NO. 4 | DESCRIPTION OF REVISION - TRAFFIC-RATED PULL BOX DIMENSIONS AND C&C SCHEDULE REVISIONS | MADE BY - FAK | DATE - 11/26

ARIZONA DEPARTMENT OF TRANSPORTATION
PROJECT DELIVERY AND OPERATIONS DIVISION
PROJECT MANAGEMENT GROUP
T0621 BISBEE WEST
LEGEND/CONSTRUCTION NOTES SHEET

LOCATION SR80; QUEEN MINE TOUR - OLD BISBEE
DWG NO. L-01.02
TRACS NO. T0621 01C
____ OF ____

T0621 BISBEE WEST LIGHTING SHEET

LT01
TRAFFIC RATED PULL BOX DETAIL
N.T.S

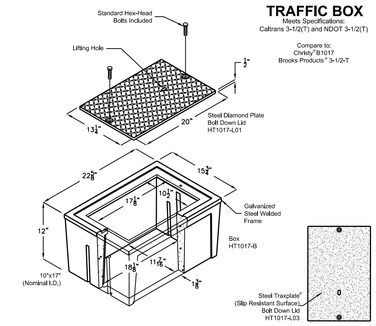
9. *Remove and dispose of existing pull box.*
10. *Install 10"x17"x24" traffic rated pull box with extension per detail LT01.* (4)
11. *Directional drill and install new conduit per conduit and conductor schedule.*

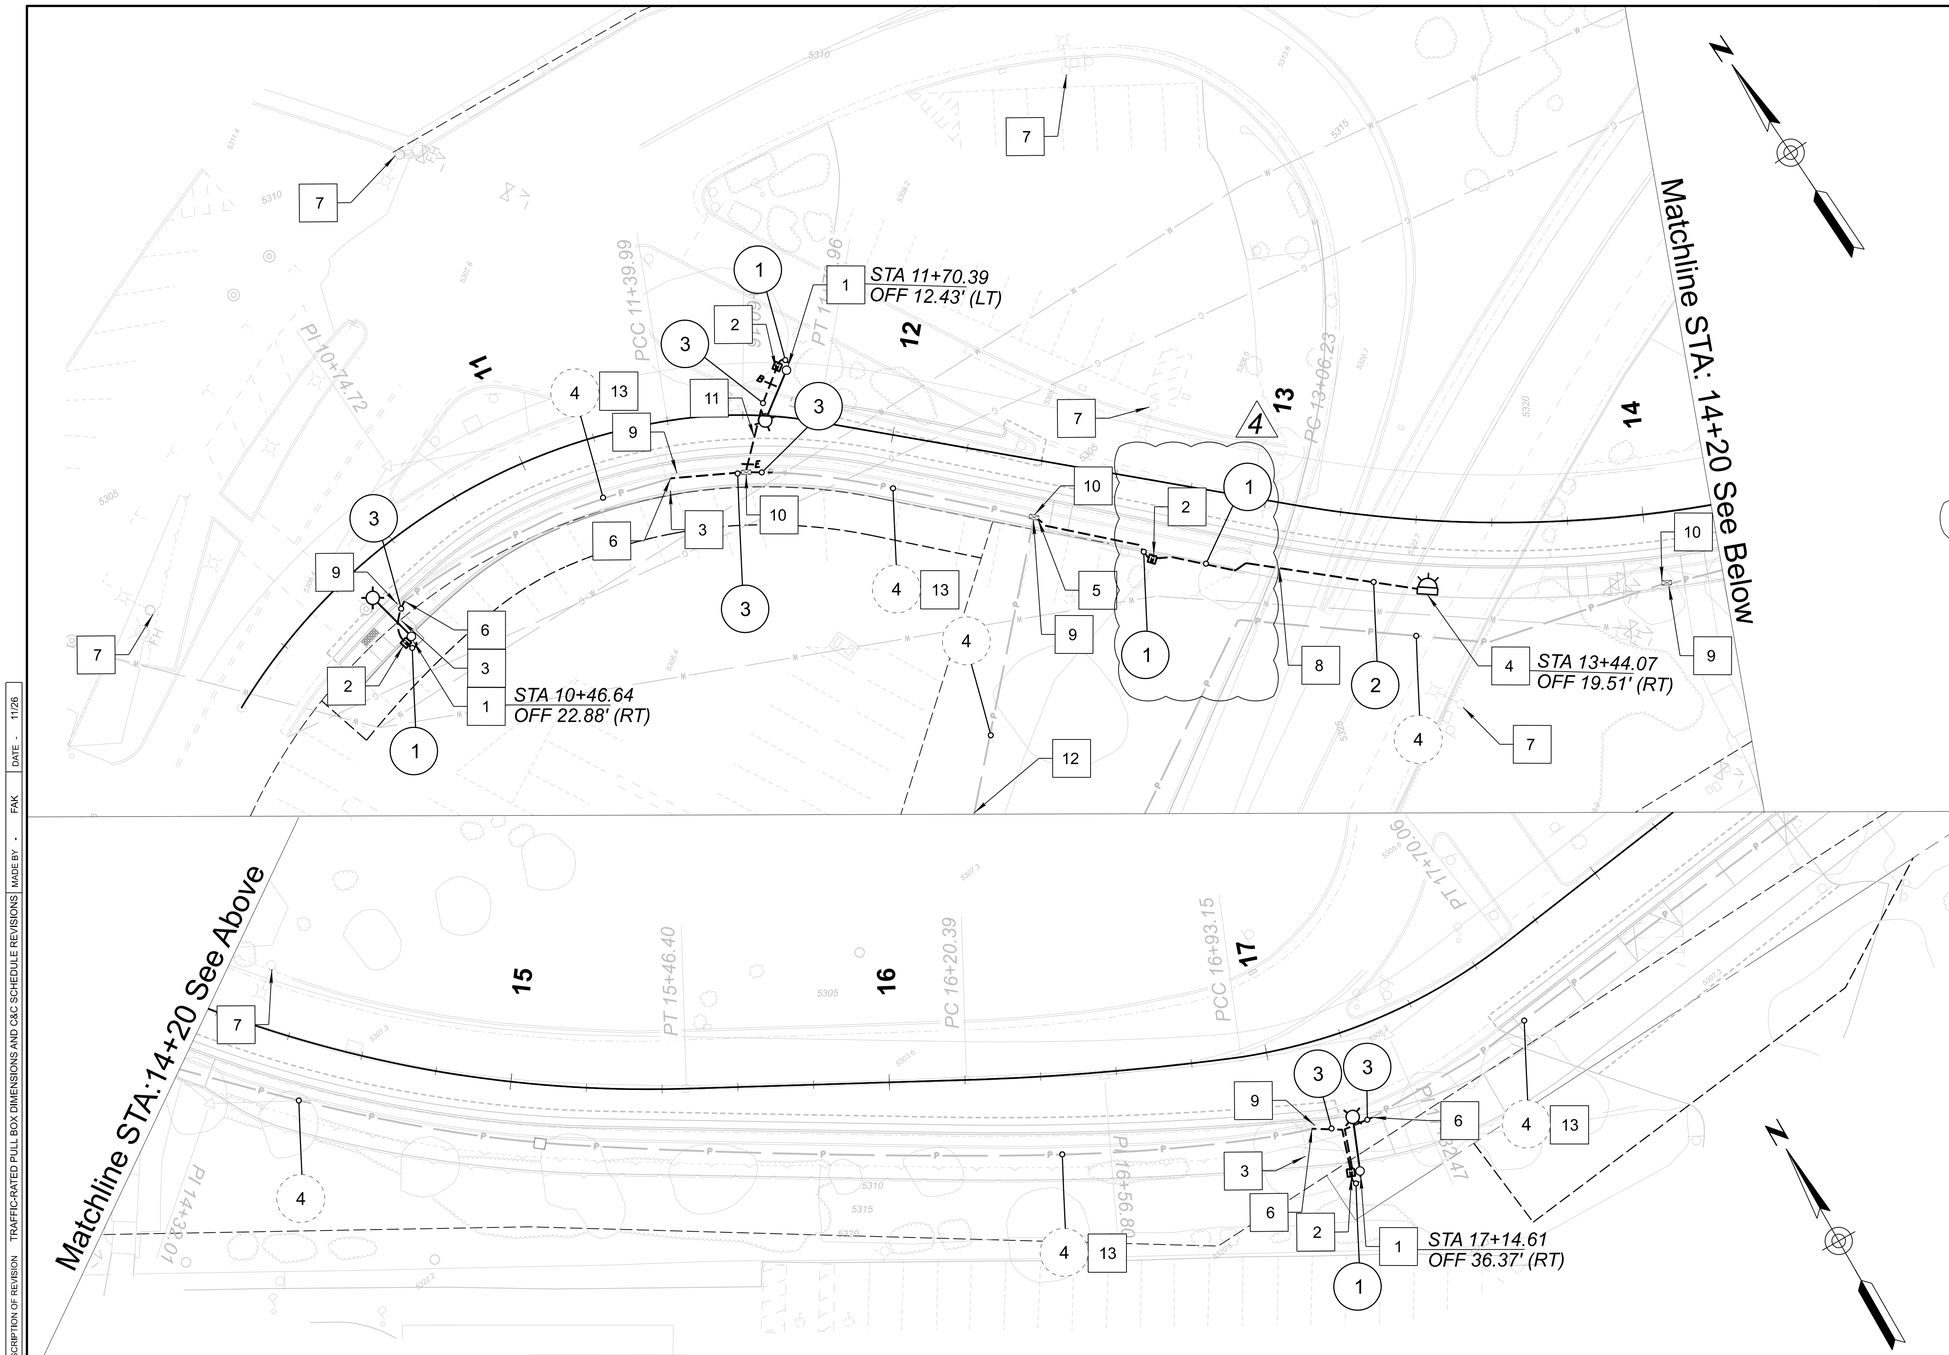
| NO. | DESCRIPTION OF REVISION | MADE BY | DATE |
|---|---|---|---|
| 4 | TRAFFIC-RATED PULL BOX DIMENSIONS AND C&C SCHEDULE REVISIONS | FAK | 11/26 |

9. *Remove and dispose of existing pull box.*
10. *Install 17"x24" traffic rated pull box per detail LT01 on sheet 24*
11. *Directional drill and install new conduit per conduit and conductor schedule.*

12. *Continuation to load center on pole.*
13. *Continuation from note 3 per the conduit & conductor schedule until the nearest pull box.*
